# LOWRY VISTA

## ADDENDUM

To the **DESIGN GUIDELINES**  
of the **LOWRY COMMUNITY**  
September 4, 2009

# IRG Redevelopment I, LLC

SECTION A - TYPICAL MAIN STREET SECTION  
NOT TO SCALE

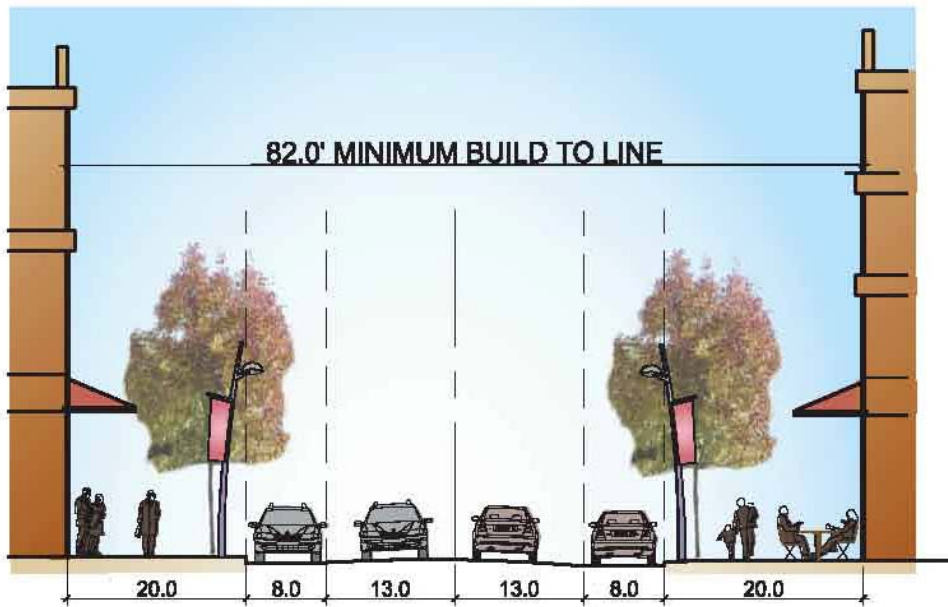
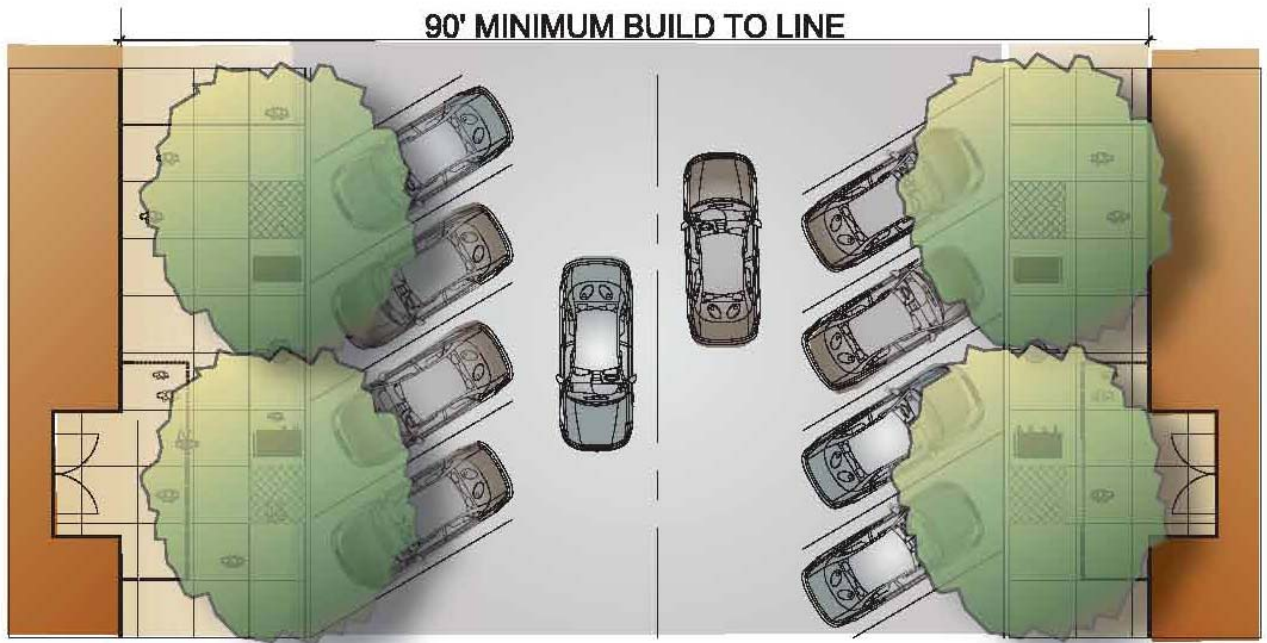
#### Section A Main Street

*Main Street* is the north-south street that runs through the center of the site with an eighty (80) foot typical building line and parallel parking on both sides.

**SECTION B - (Main east-west street where diagonal parking occurs)**  
 NOT TO SCALE - NOT TYPICAL OF ENTIRE STREET SECTION (REFERENCE SECTION C)

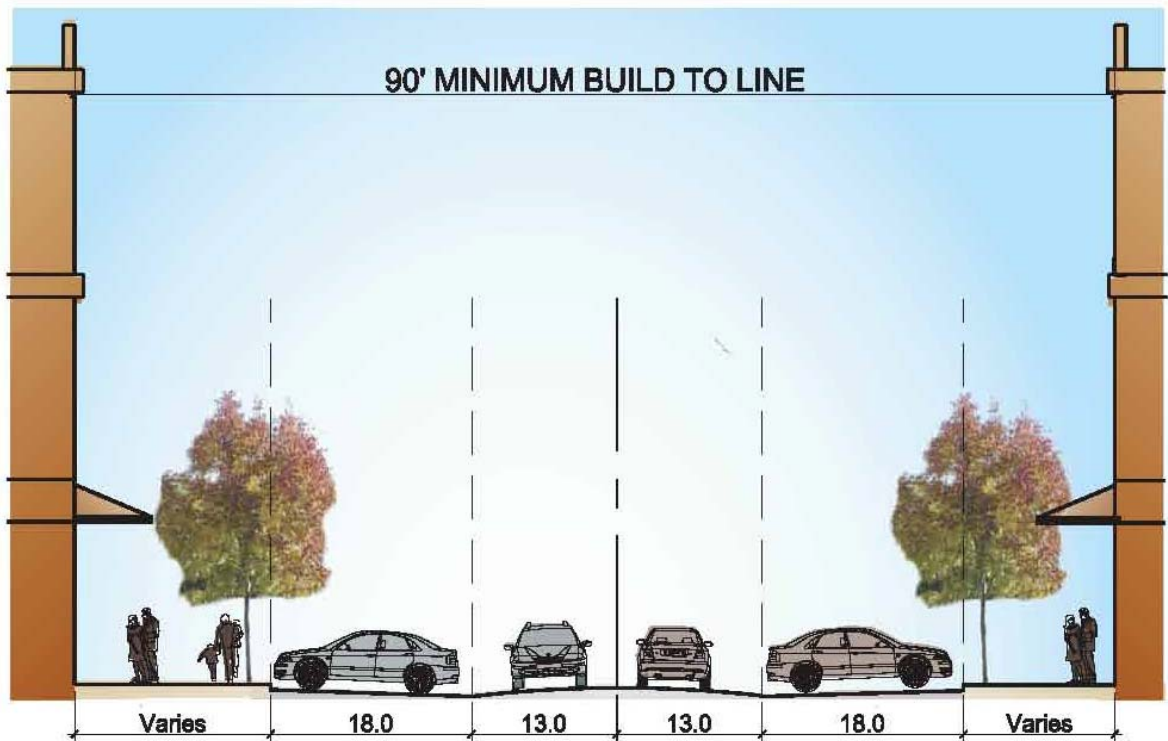
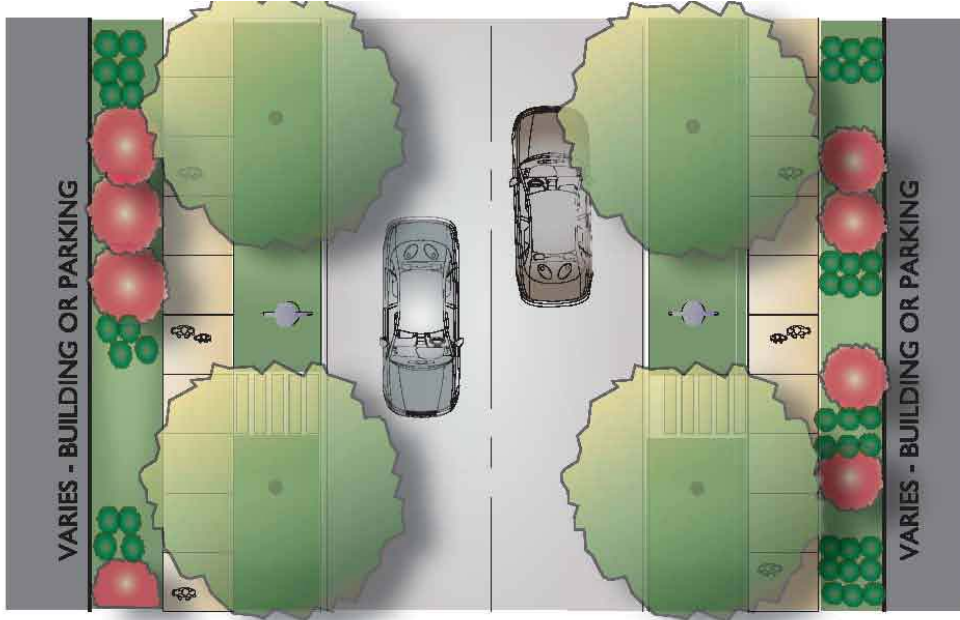
**Section B Commercial Street**

*Section B* is the primary east-west street that consists of a ninety (90) foot typical building line with on-street parallel and/or diagonal in select locations close to Main Street.

SECTION C - (Main east-west street where no parking occurs)  
NOT TO SCALE - NOT TYPICAL OF ENTIRE STREET SECTION (REFERENCE SECTION B)

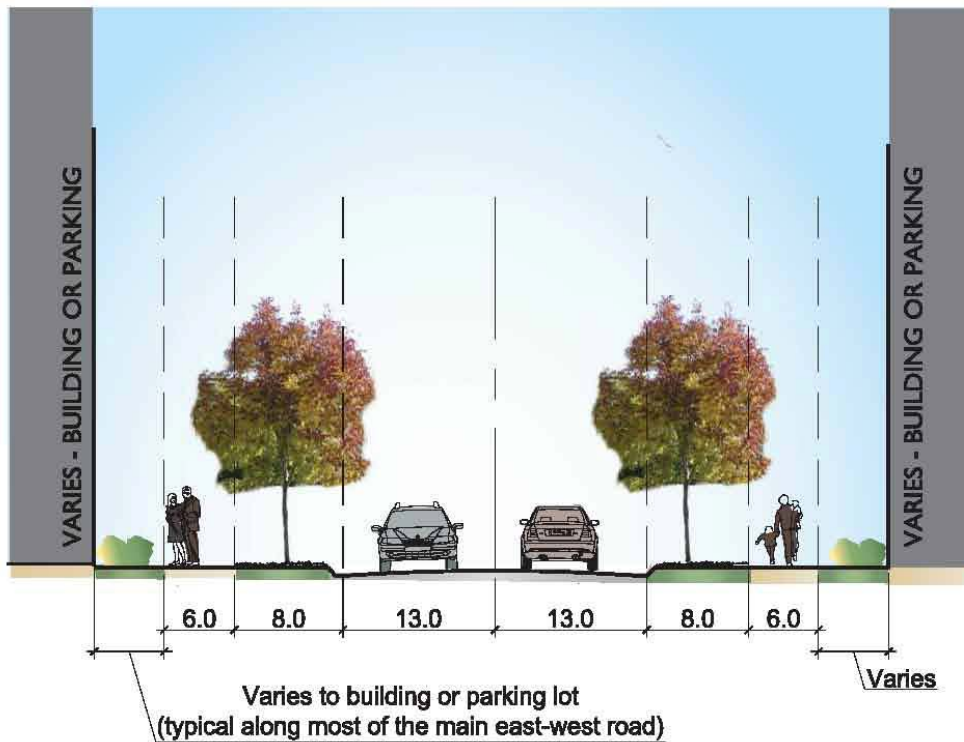
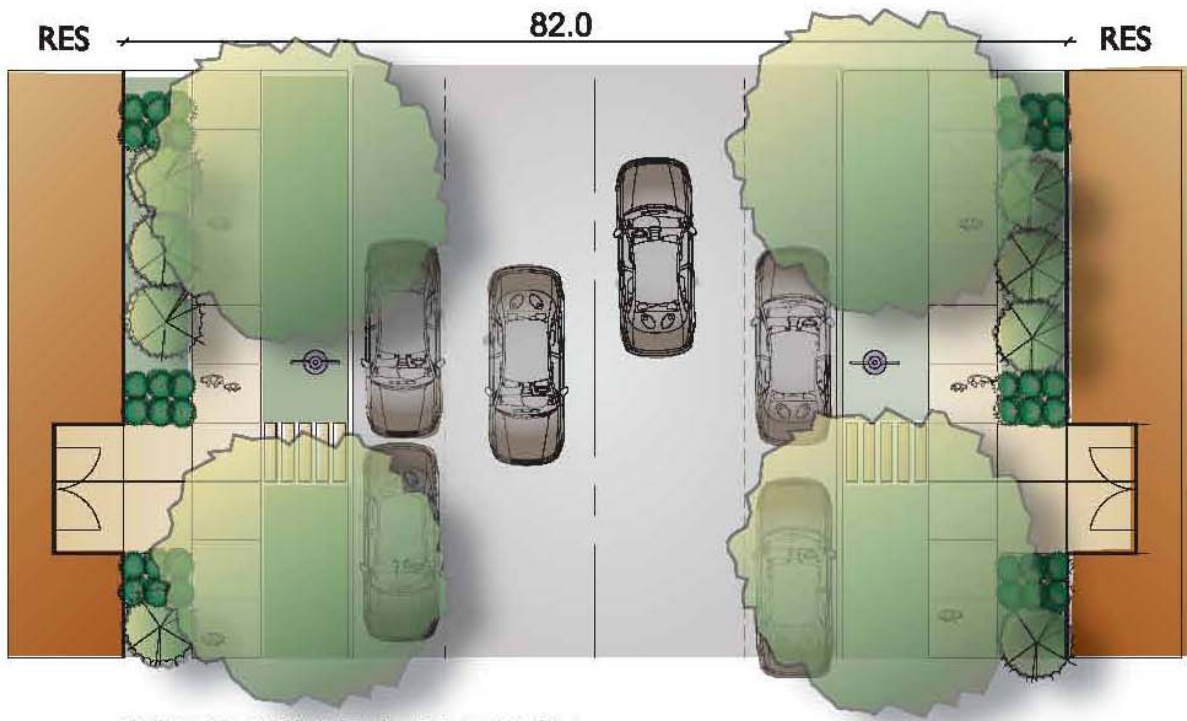
**Section C Commercial Street**

*Section C* is the primary east-west street where there is no on street parking. This section of street is further from Main Street and serves as a traffic/pedestrian mover. It is typically adjacent to parking lots or other commercial/residential use.

**SECTION D / E - 82' RESIDENTIAL STREET**  
NOT TO SCALE

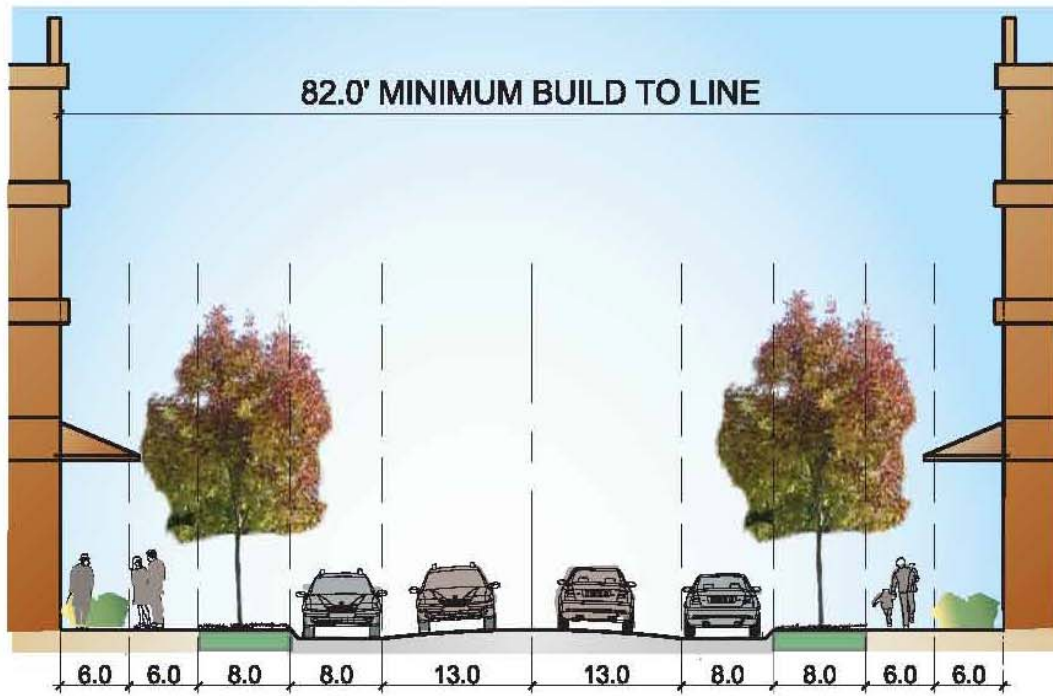
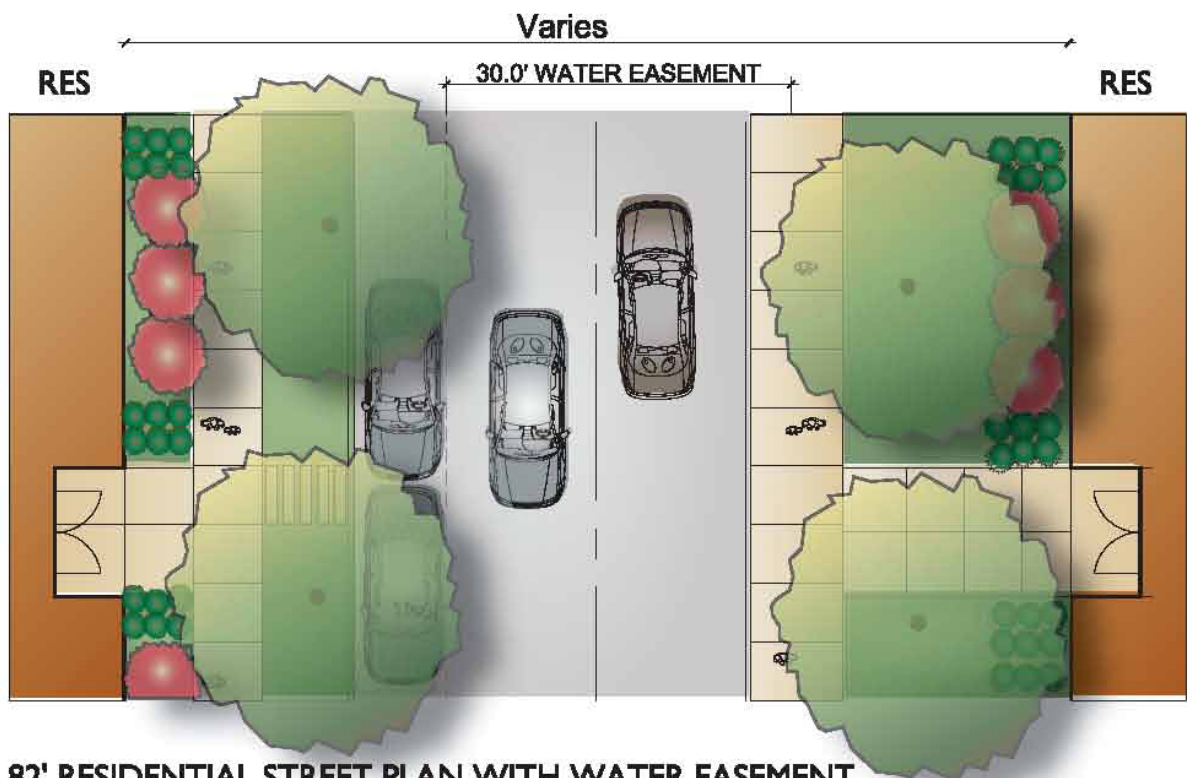
**Section D / Section E Residential Street**

*East and North Residential Streets* are all residential, with an eighty-two (82) foot typical building line including parallel parking on both sides and a six (6) foot detached walk, .

**ALTERNATE SECTION D / E**  
 \* MAY BE USED TO ACCOMMODATE WATER EASEMENT  
 NOT TO SCALE

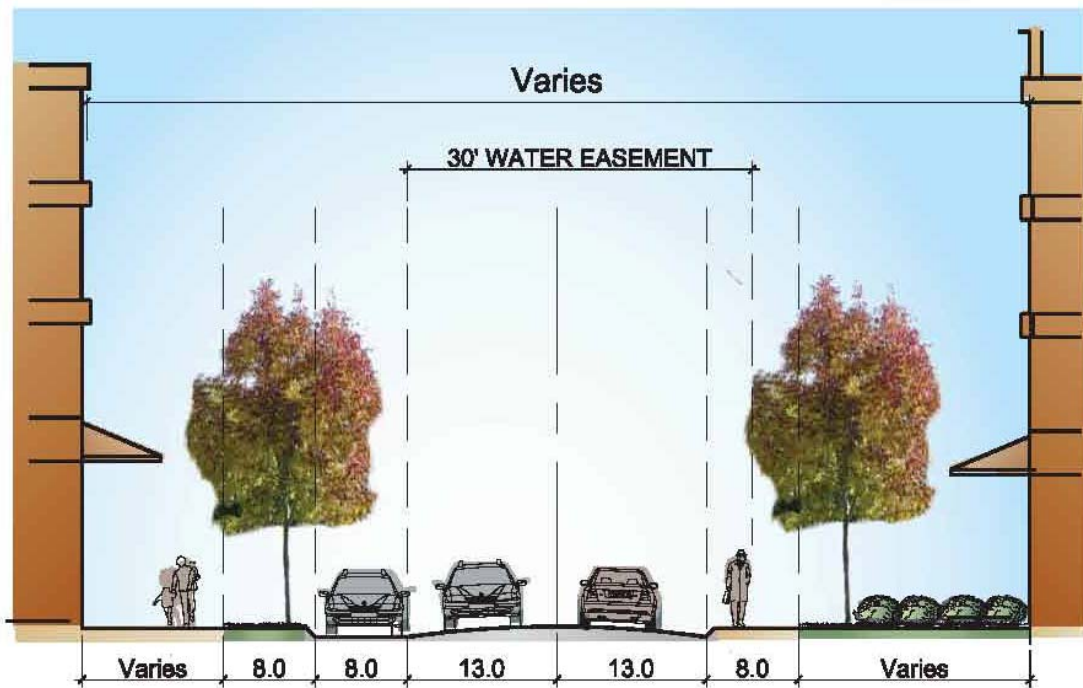
**Alternate Section D / Section E Residential Street**

*East and North Residential Streets* are all residential, with an eighty-two (82) foot typical building line including parallel parking and a detached six (6) foot walk on one side, and an attached walk on the other side. The *Alternate Sections* will be used in the event of a required waterline easement.
